STATE OF NORTH CAROLINA
DEPARTMENT OF TRANSPORTATION

Subject: **Modification to Section 404 Individual Permit and Section 401 Water Quality Certification and Neuse Buffer Certificate** for Northern Wake Expressway from NC 55 west of Morrisville to 0.7 km northeast of I-40 in Wake and Durham Counties (TIP Nos. R-2000AA, R-2000AB; and R-2000AC); State Project No. 8.U401711; Federal Aid Project No. NHF-123-1(11). USACE Action ID No. 200021863 (Previous Action ID. No. 199920387 and Action ID No. 199601917), NCDENR-DWQ Project No. 030918; \$475.00 Debit WBS Element 34365.1.2

The North Carolina Department of Transportation (NCDOT) is currently constructing a portion of the Northern Wake Expressway in Wake and Durham Counties (R-2000 Sections AA, AB and AC). The United States Army Corps of Engineers (USACE) originally issued an Individual Permit for this project on October 10, 1996. The USACE issued a permit modification for the construction of this project on November 25, 2003. The North Carolina Division of Environment and Natural Resources, Division of Water Quality issued the 401 Water Quality Certification No. 3439 (NCDENR-DWQ Project No. 030918) for this project on October 7, 2003

PLAN VIEW
 SITE 1

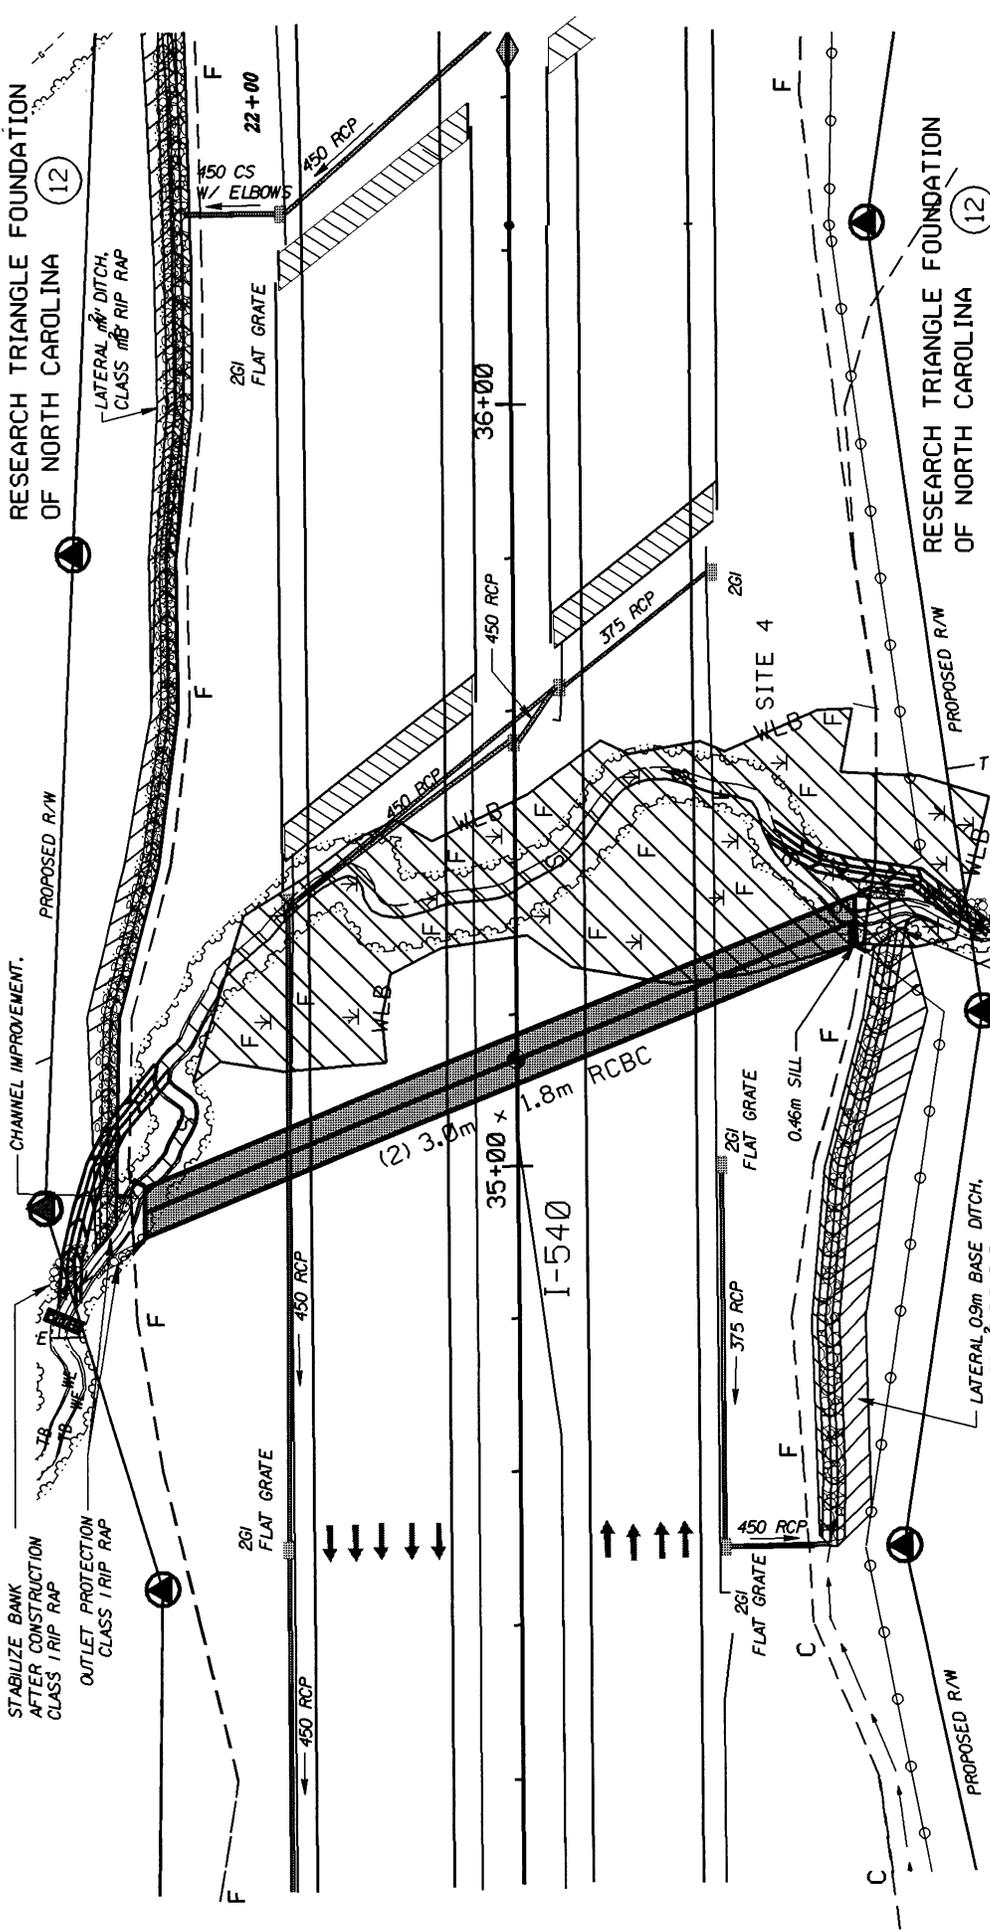
Issue: The permitted footprint of the stream depicted on the permit drawing appears to originate and terminate without any conveyance to a live stream. A recent field visit indicates that the jurisdictional limits of the stream were not correctly identified on the permit drawing dated 4/23/03.

Status: The permit drawing was modified (5/26/04) to depict the correct stream conveyance.

Rev. 9 OF 19 DATE 6/28/04
SHEET

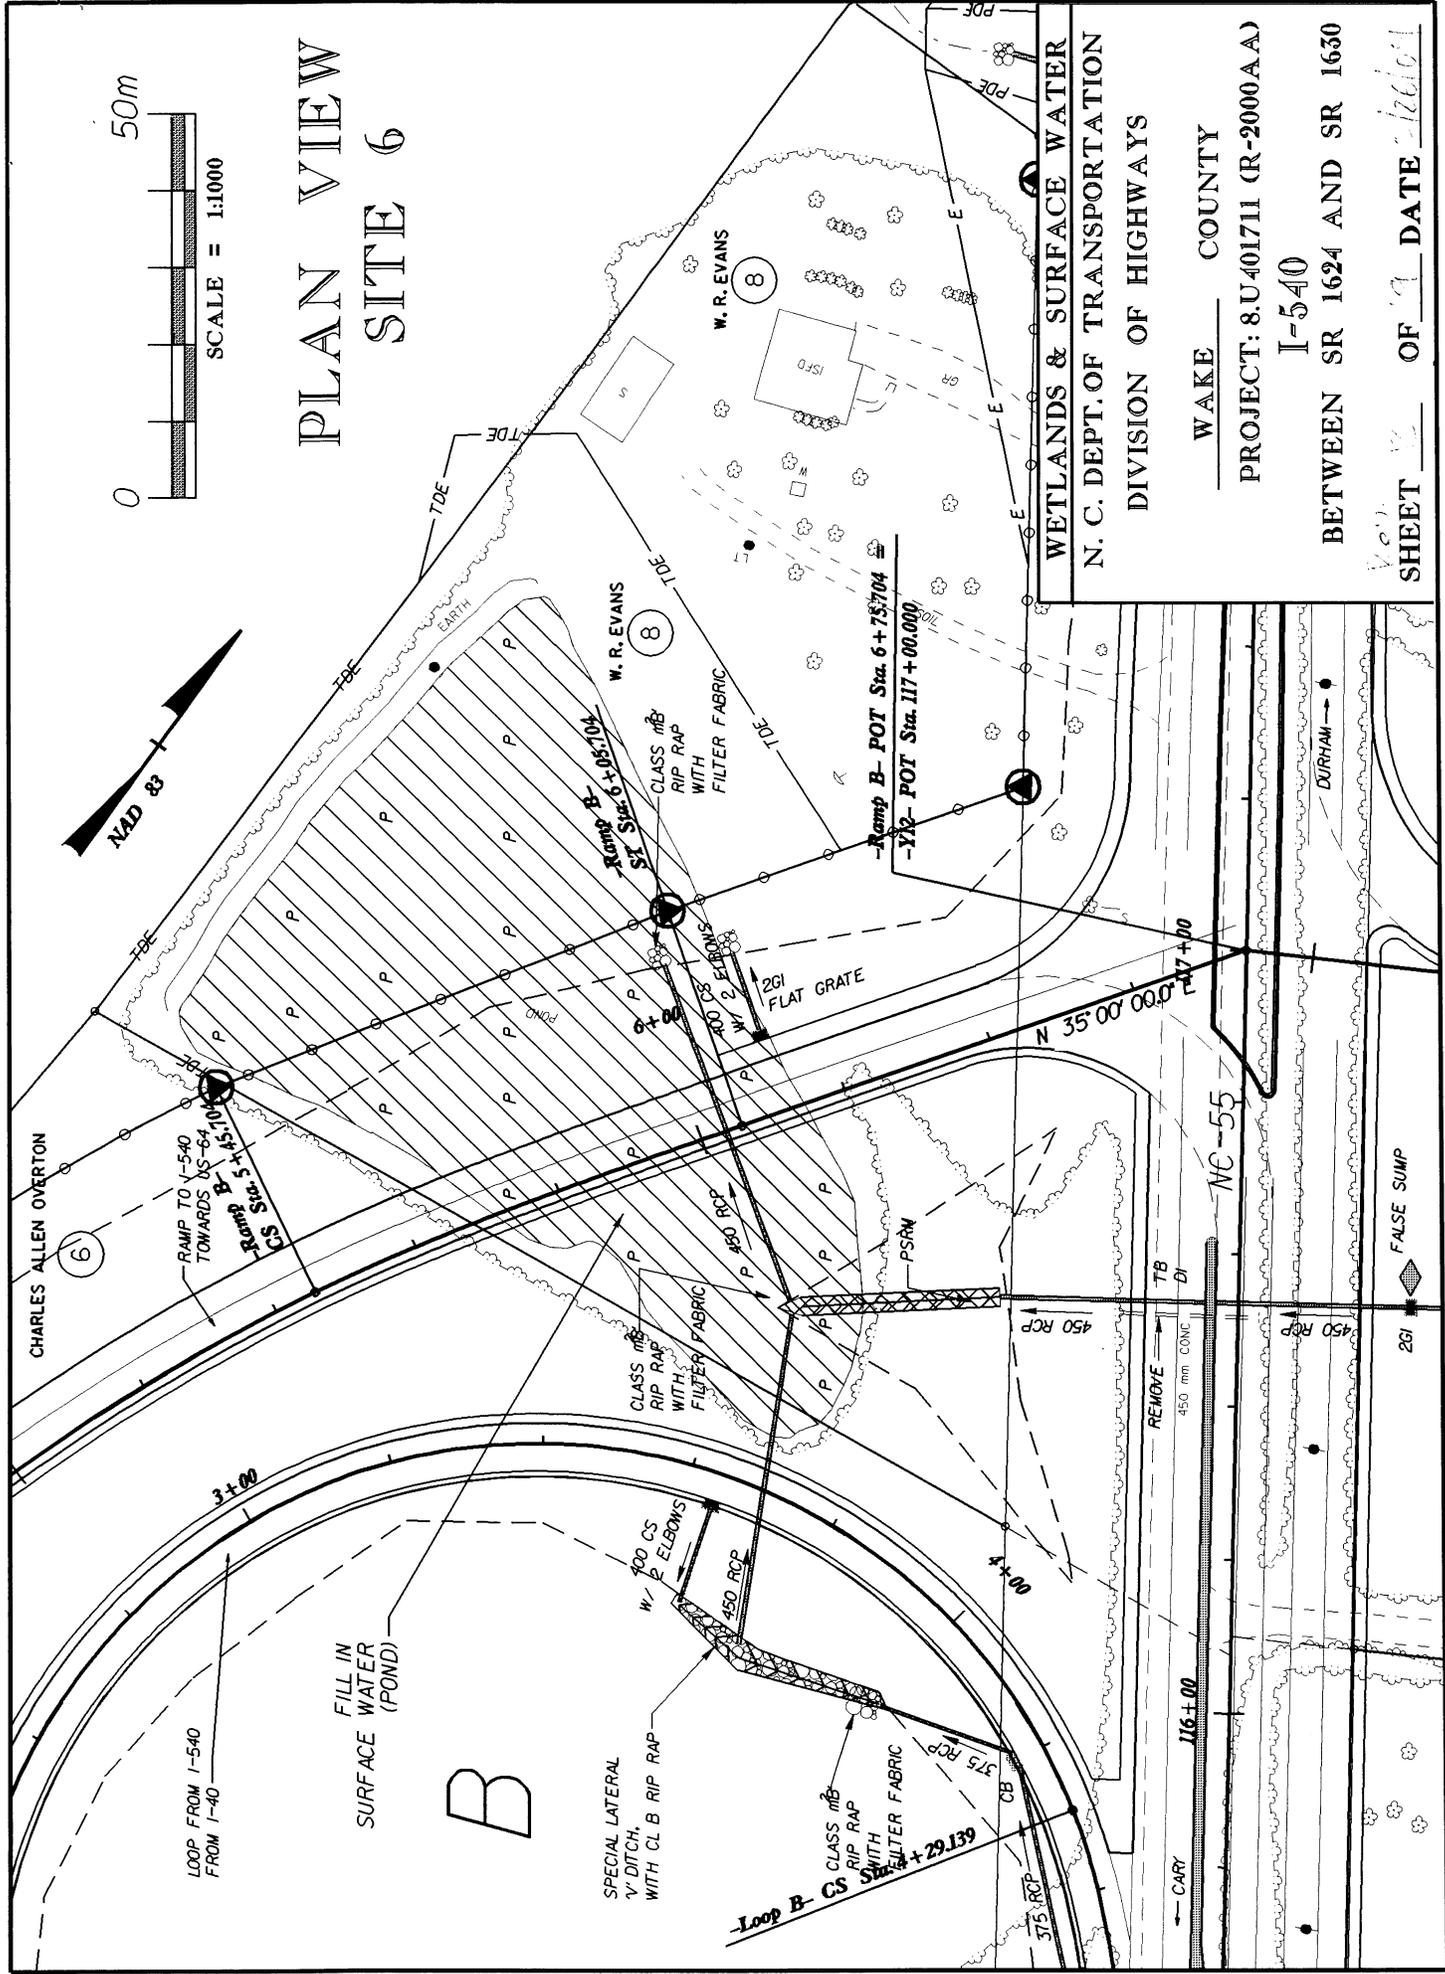
Issue: The plan sheet indicates the presence of rip rap along the streambank at the inlet of the culvert. This rip rap is not depicted on the permit drawing (undated).

Issue: The tie in points of the temporary channel change as depicted on EC-11 are located outside of the permitted stream and wetland footprint as depicted on the permit drawing (undated).

Status: Permit drawing was modified (6/28/04) to depict rip rap along the streambank.

Status: Permit drawing was modified (5/26/04) to depict revised stream and wetland impact that will capture the tie in points of the temporary channel change.

Rev. SHEET 15 OF 67 6/9/04

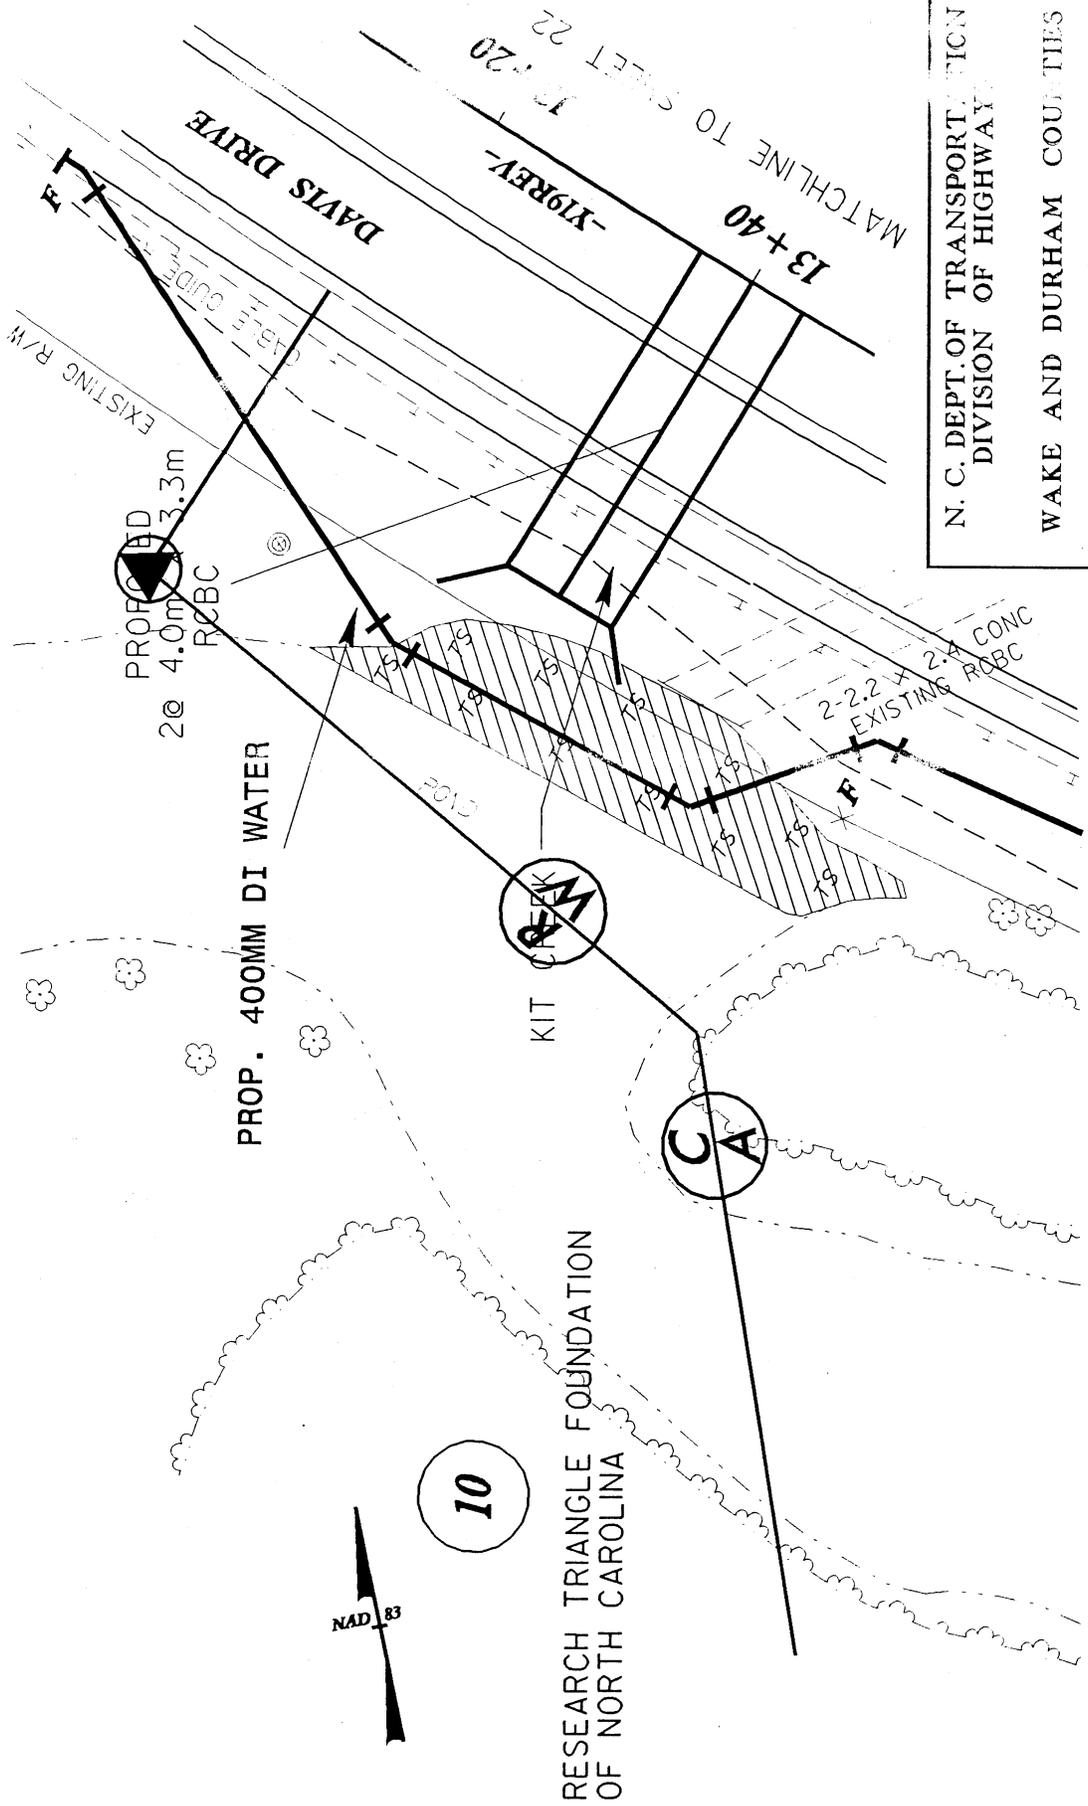
Issue: The plan sheet depicts rip rap at the outlet of a 400 mm corrugated steel pipe at Station 14+29 Rt YRPB. Permit drawing 15 (7/03) depicts a pre-formed scour hole at the outlet of the pipe structure.

Issue: The plan sheet depicts rip rap along the toe of the fill in the wetland and pond. This rip rap is not depicted on permit drawing 15 (7/03). Please note Plan Sheet 2-AS, which indicates this rip rap will be keyed in beyond the toe of the fill.

Status: Plan sheet has been revised to depict a pre-formed scour hole at the outlet of the structure.

Status: Permit drawing has been modified (6/9/04) to depict rip rap along the toe of the fill in the wetland and pond.

PLAN VIEW
SITE 4

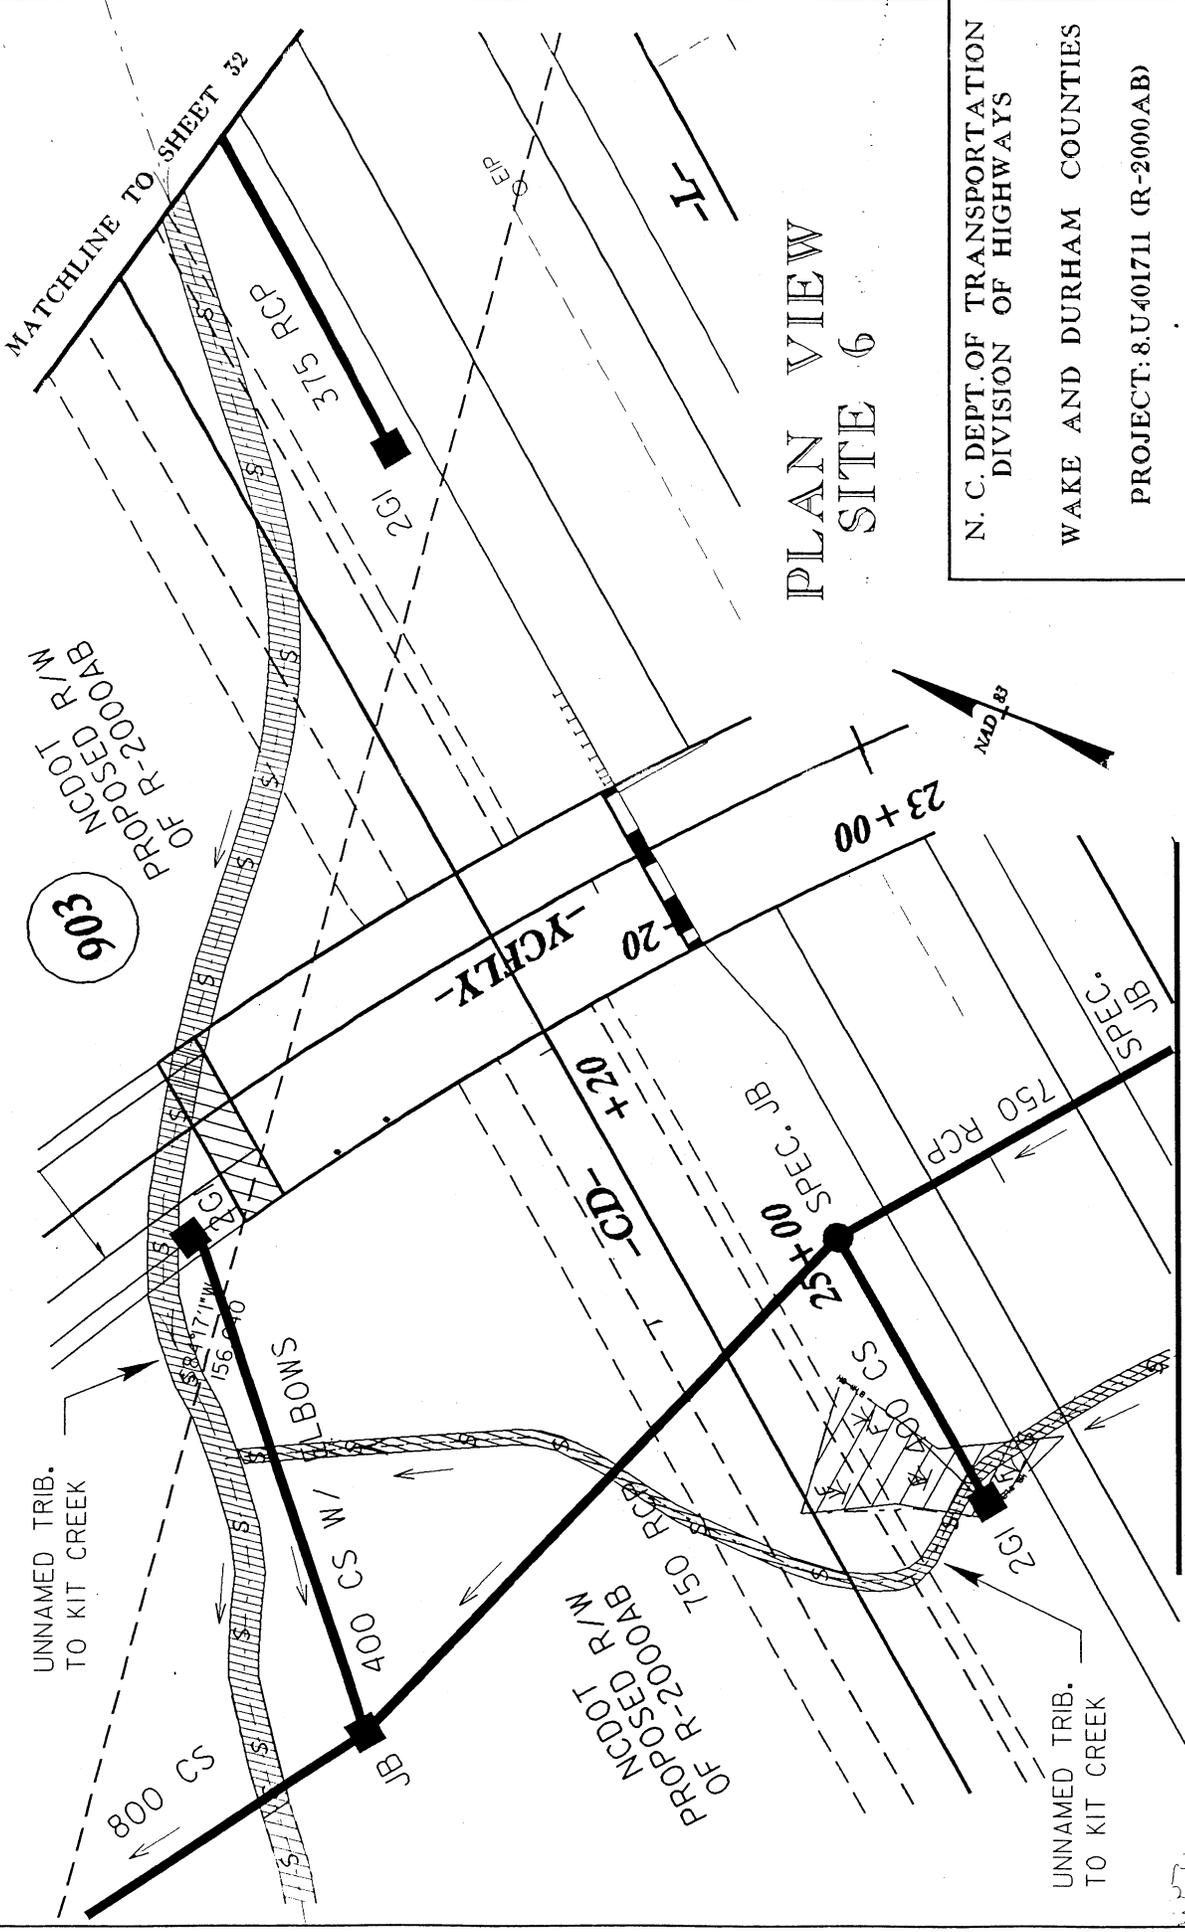
Issue: The tie in point of the temporary channel change at the inlet of the structure as depicted on EC-6 is located outside of the permitted stream footprint as depicted on the permit drawing (7/03).

Issue: The plan sheet depicts rip rap along both streambanks at the inlet of the structure and rip rap/channel improvement along the northeast streambank at the outlet of the structure. The rip rap and rip rap/channel improvement was not depicted on the permit drawing (7/03).

Status: Permit drawing has been modified (6/9/04) to depict a revised stream impact at the inlet of the structure that will capture the tie in point of the temporary channel change.

Status: The permit drawing has been modified (6/9/04) to depict rip rap and rip rap/channel improvement along the streambank.
